Access Compliance Report Public Rights-of-Way (Curb Ramps)

Main Street: ESENCIA_DR Cross Street: N/A Location: SE

ADA ID: RPRK211129143338 Ramp Type: Type 1 - Perpendicular Diagonal Initial Pass/Fail: Fail Overall Compliance: No Severity Score: 2

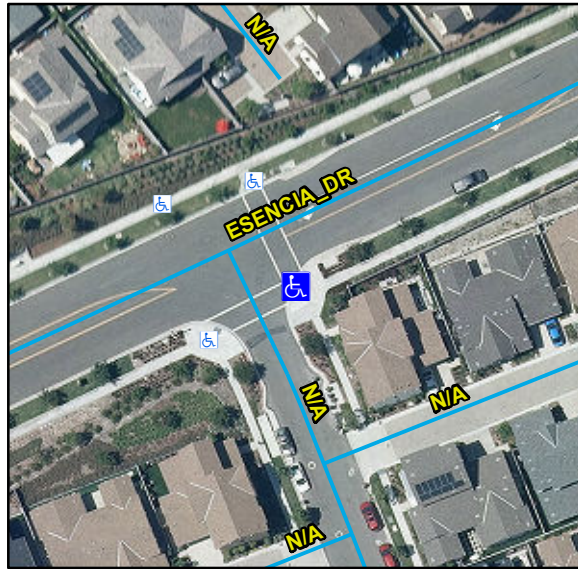
R304.2.2, R304.5.3, STD 1115

Remove & Replace Curb Ramp With Two New Directional Ramps or Equivalent.
